WATER QUALITY MEMORANDUM

Utah Coal Regulatory Program

RE: 2011 First Quarter Water Monitoring, Sunnyside Cogeneration Association, Sunnyside Refuse/Slurry, C0070035, WQ11-1, Task ID 3762

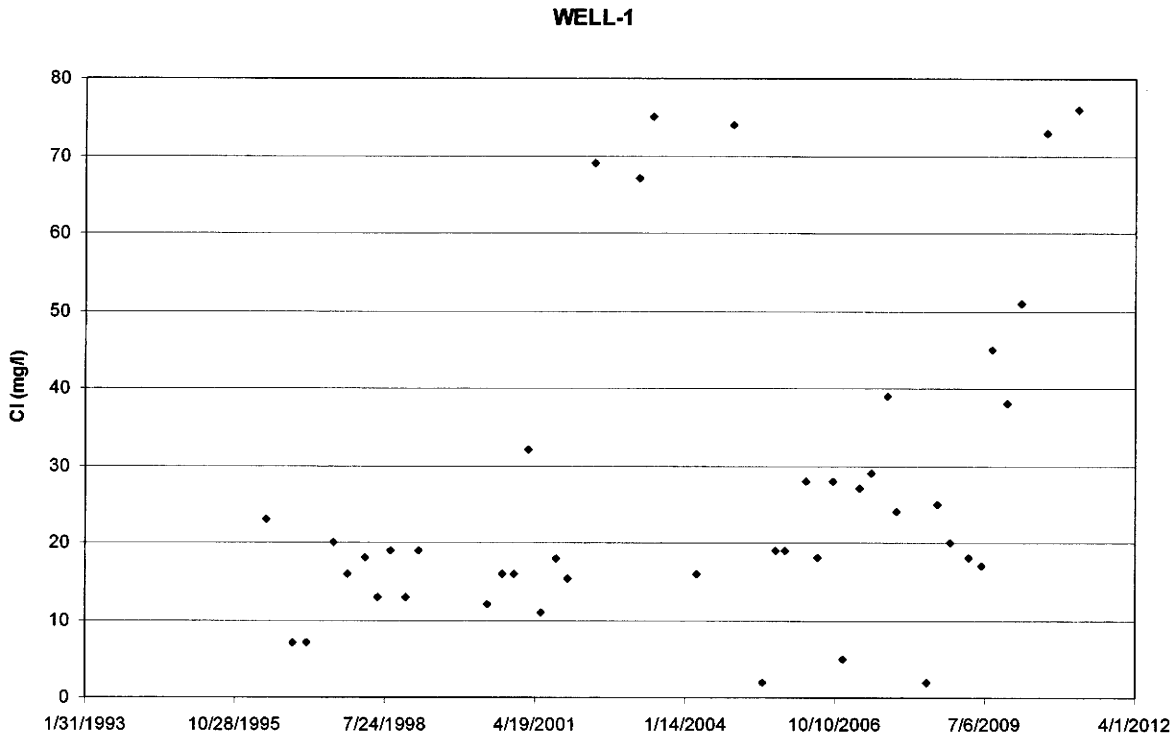
The chloride concentration reported for WELL-1 (76 mg/L) is above the average value for this site by greater than two times the standard deviations. The chloride concentration at WELL-1 has exceeded 70 mg/L three times previously: 75 mg/L during second quarter 2003, 74 mg/L in fourth quarter 2004, and 73 mg/L in third quarter 2010. The graph below displays the wide variance in chloride concentrations.
